APPENDIX 2V.
MEMO FROM P. GREALY RE:
ROADWAY WIDTH
DATED APRIL 28, 2008

MEMORANDUM

TO: Gerald Jacobowitz, Esq.
FROM: Philip J. Grealy, Ph.D., P.E.
DATE: April 24, 2008
SUBJECT: Cornwall Commons – Roadway Widths
PROJECT: No. 173
COPY TO:

ALTERNATE-1
 - 28' CURB TO CURB
 W/ PARKING
 - 21' REMAINING
 TRAVELWAY

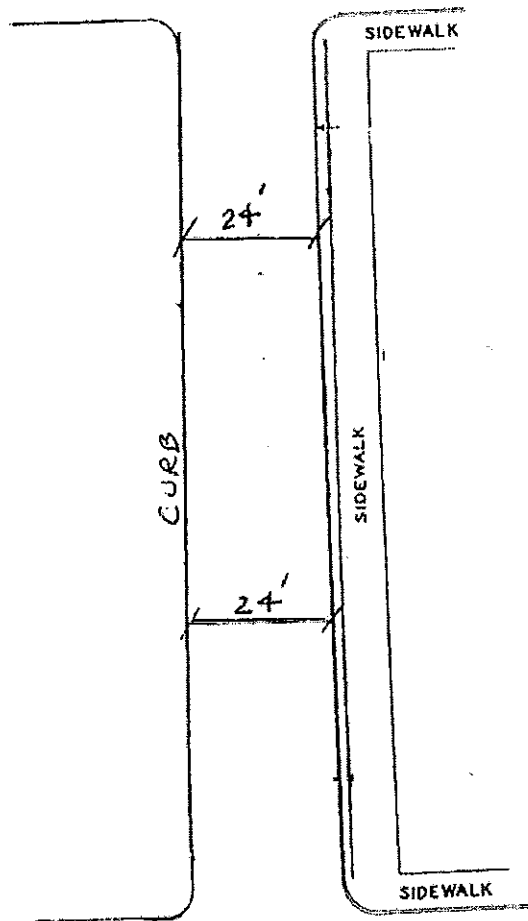
As a follow up to our telephone conversation, the following are my observations regarding roadway widths including a 24' wide roadway within a 40' right-of-way with no parking allowed along the roadway versus a 28' wide roadway with parking allowed on one side.

The allowance for a parallel parking space is between 7' and 8' and with the 28' roadway, this would leave an effective travel width of between 20' and 21' (See Alternate 1). The 24' curb to curb roadway width with no parking would provide a 24' wide travel way (see Alternate 2). It is our understanding that beyond the curb line, there will be grass strip and sidewalk which provides additional free area where emergency vehicles could traverse if necessary. In addition, in the vicinity of the hydrants, the roadway could be "bumped out" to a 26' width to satisfy the New York State Building Code
